Contract #: 04-0120F4Cty: SF/ALA Rte: 80 PM: 13.2/13.9File #: 69.25B**QUALITY ASSURANCE -- NON-CONFORMANCE REPORT****Location:** Changxing Island, Shanghai, P.R. China**Report No:** NCR-000655**Prime Contractor:** American Bridge/Fluor Enterprises, a JV**Date:** 26-Jan-2010**Submitting Contractor:** Zhenhua Port Machinery Company, Ltd (ZPMC), Changxing Island**NCR #:** ZPMC-0626**Type of problem:**

Reference Description: Missed UT indication by QC on Side Plate to Bottom Plate Joint on Segment 12BE**Description of Non-Conformance:**

Job Name: SAS Superstructure

Subject: NCR No. ZPMC-0626

WELD NUMBER: SEG3002A-001

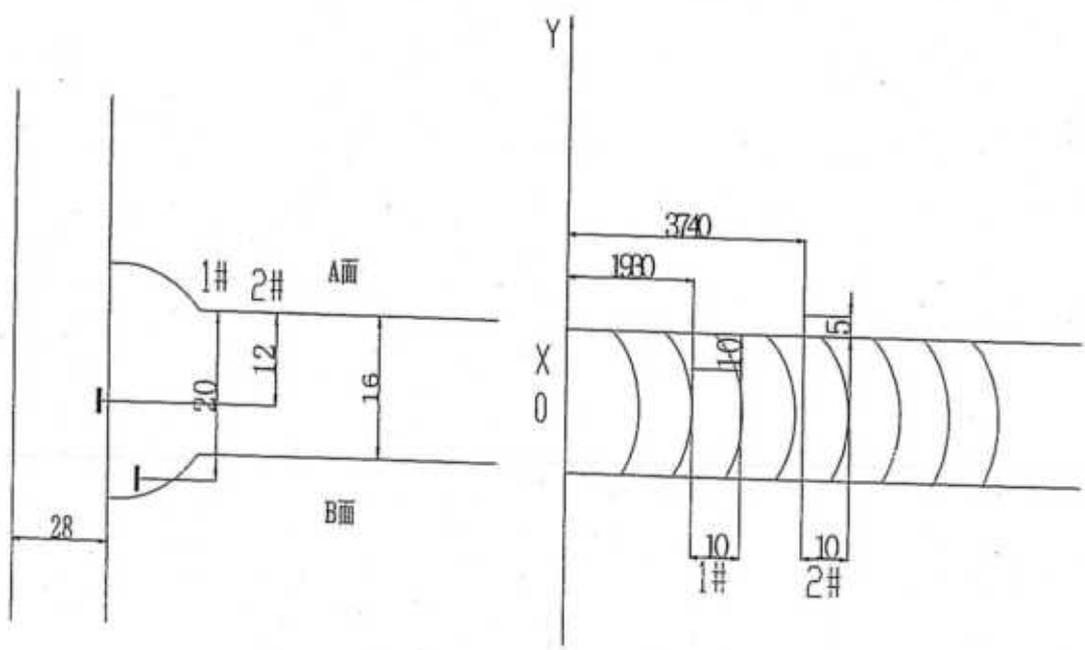
Description of welding discontinuity:

Rejected indication found by ultrasonic inspection is less than the maximum allowance aggregate length.

(UT探伤发现的缺陷总长度小于最大允许长度。) SEG3002A-001

1. Did not clear the weld pass completely in time.

1. Gouge or grind from nearer side from metal edge ($D \leq 0.65T$, "D" is depth of defects, "T" is thickness of metal) to remove all defects;

2. Follow repair WPS for joint preparation, preheat, and weld deposit;

3. Verify with VT no defects remain in the weld joint prior to welding;

4. Grind the repaired area flush with base metal or the adjacent weld;

5. Perform UT inspection to the weld along with 50mm on each end of the repair area;

(UT探伤发现的缺陷总长度小于最大允许长度。) SEG048*-008

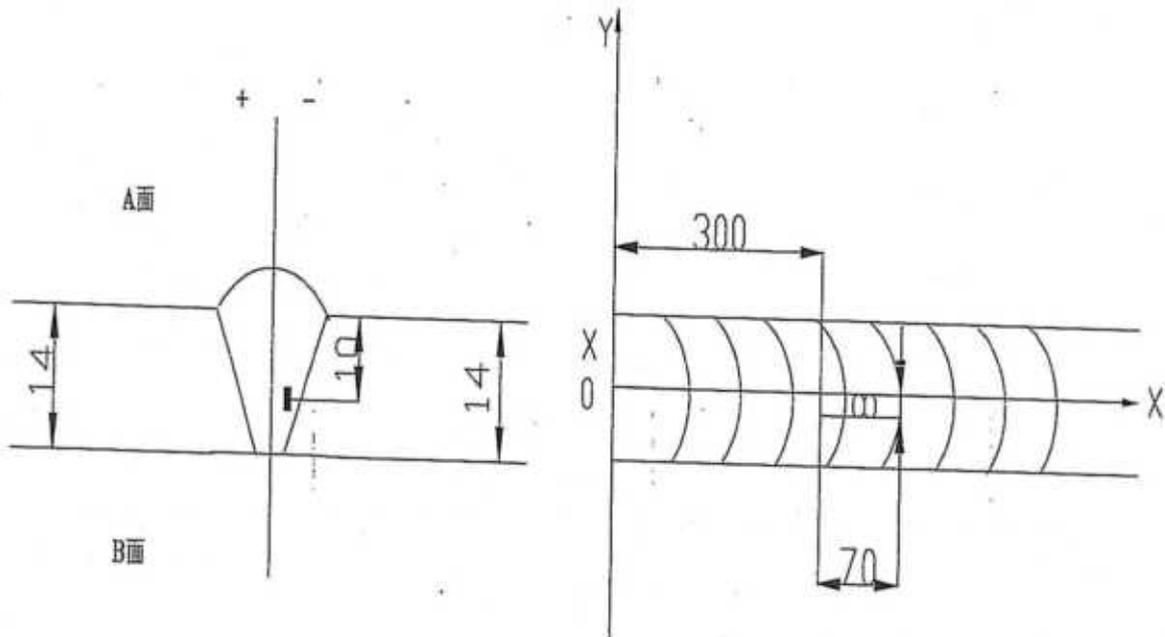
Description of welding discontinuity:

Rejected indication found by ultrasonic inspection is less than the maximum allowance aggregate length.

1. 从缺陷距离端面较近一侧 ($D \leq 0.65T$, D 为缺陷深度, T 为板厚) 采用碳刨或打磨的方法去除焊缝缺陷;
 2. 参照返修焊接工艺规程 (WPS) 准备正确的接头型式, 预热和焊接;
 3. 焊前对修补区域进行VT检测保证缺陷完全被清除;
 4. 将修补区域打磨到与母材或邻近焊缝平齐;
 5. 对焊缝进行UT检测, 检测范围为返修区域以及其两端各延长50mm.
-
1. Gouge or grind from nearer side from metal edge ($D \leq 0.65T$, "D" is depth of defects, "T" is thickness of metal) to remove all defects;
 2. Follow repair WPS for joint preparation, preheat, and weld deposit;
 3. Verify with VT no defects remain in the weld joint prior to welding;
 4. Grind the repaired area flush with base metal or the adjacent weld;
 5. Perform UT inspection to the weld along with 50mm on each end of the repair area;

(UT探伤发现的缺陷总长度小于最大允许长度。) SEG050A-003

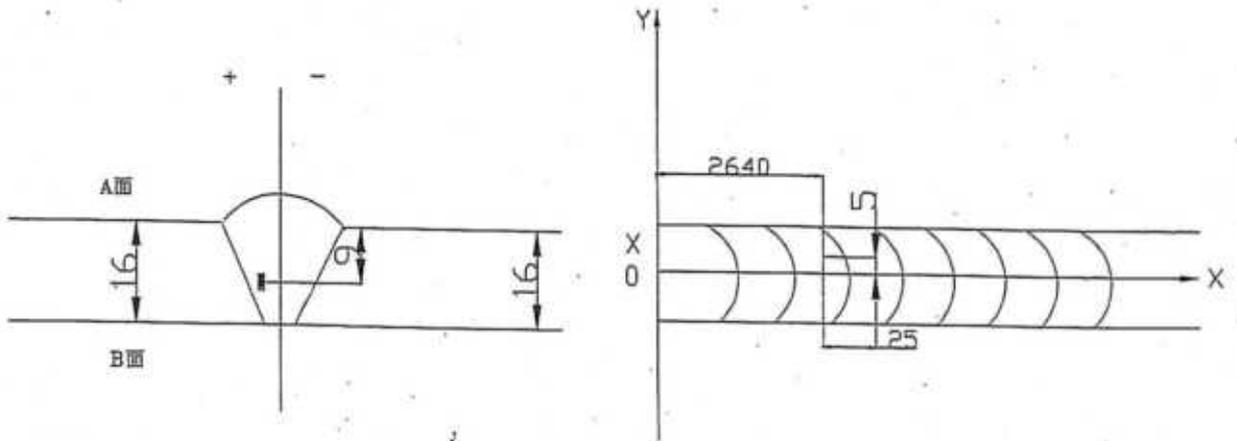
Description of welding discontinuity:

Rejected indication found by ultrasonic inspection is less than the maximum allowance aggregate length.

1. Gouge or grind from nearer side from metal edge ($D \leq 0.65T$, "D" is depth of defects, "T" is thickness of metal) to remove all defects;
2. Follow repair WPS for joint preparation, preheat, and weld deposit;
3. Verify with VT no defects remain in the weld joint prior to welding;
4. Grind the repaired area flush with base metal or the adjacent weld;
5. Check the welds according to the working drawings;

(UT探伤发现的缺陷总长度小于最大允许长度。) SEG050A-003

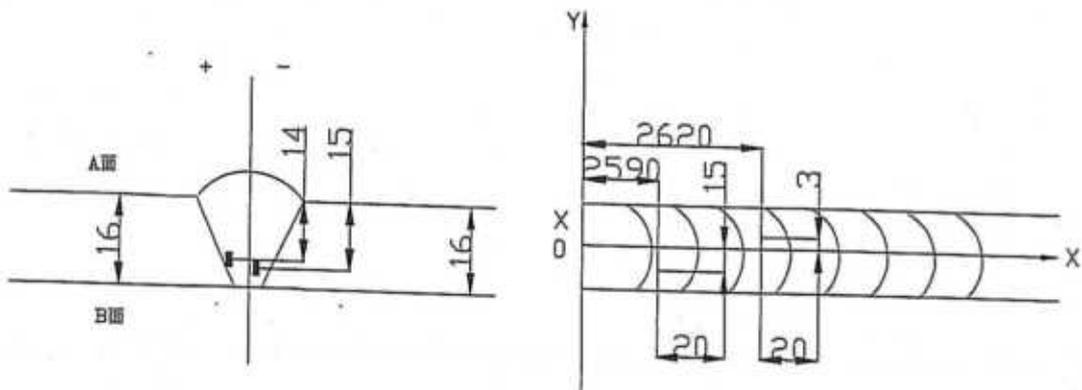
Description of welding discontinuity:

Rejected indication found by ultrasonic inspection is less than the maximum allowance aggregate length.

1. Gouge or grind from nearer side from metal edge ($D \leq 0.65T$, "D" is depth of defects, "T" is thickness of metal) to remove all defects;

3. Verify with VT no defects remain in the weld joint prior to welding;
